MEMORANDUM

Preliminary Plan of Subdivision

PROJECT NAME: Dzyak Property

120050670

Attachment B – Proposed Development Plan

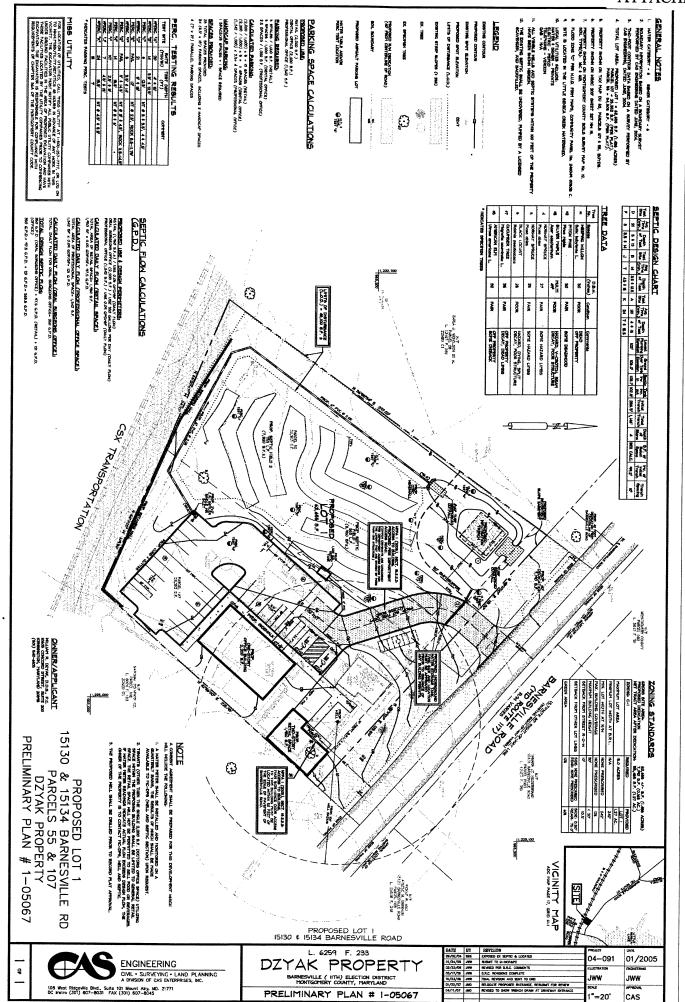
I will remind everyone concerned with the decisions of what is to be allowed on this property that we are in the Historical District of Boyds. With that in mind, I see a proposed infiltration trench to be built right along Barnesville Road. How lovely! The beautiful lake across the street and a mud pond along the road. Is this pond to be a dry pond? Typically, these ponds collect trash — who will put on boots and clean this unsightly mess? I don't see a fence around this pond, surely one is planned for the safety of the children and animals in the area. Again, with a fence surrounding this pond — what a lovely sight along the main road in towndown historic Boyds.

A huge consideration of mine is — my 30 foot hand dug well approximately 65 feet from a 'proposed' septic field on the Dzyak property. One issue I find extremely interesting on this 'preliminary plan' is a one hundred foot radius circle is clearly drawn from the Dzyak property well to the proposed 1,500 gallon septic tank and is therefore farther from the proposed septic fields than one hundred feet. The same kind of circle is drawn from my well, with a line forced to one hundred feet! Was this not supposed to be seen by anyone in the decision making process? It clearly makes me very angry. How

many times do I have to say that I have one well and it is 30 feet deep and it is less than 60 feet from the adjoining property line? Am I stupid - or is it just hoped that I'm that stupid? From this 'preliminary plan' my professional expert cannot determine the direction in which the septic field is draining. Could it be what it looks like, and it is draining directly toward my property which sits lower that theirs?

I also see no discussion of hours of operation to these proposed businesses that could be built right beside my residence. A lot is planned on a very small area encompassing a total of 1.27 acres. I see nothing about a buffer between the properties, just the limit of disturbance coming to the property line. I sincerely hope a buffer is planned. Apparently, the total building height is to be less than 30 feet. I will be looking forward to a fence, and trees at least 30 feet tall.

MNCPPC inspectors under a separate enforcement action. Staff spoke with Ms. Nicholson by telephone and explained that the proposed septic field locations meet county standards because they do not encroach within 100 feet of her well. Staff referred Ms. Nicholson to Gene VonGunten with MCDPS well and septic section for any additional questions regarding the septic fields. Staff also explained the stormwater management concept for the site, including the fact that the proposed infiltration trench is not intended to serve as a pond, and relayed that the concept had been determined to be adequate by MCDPS.
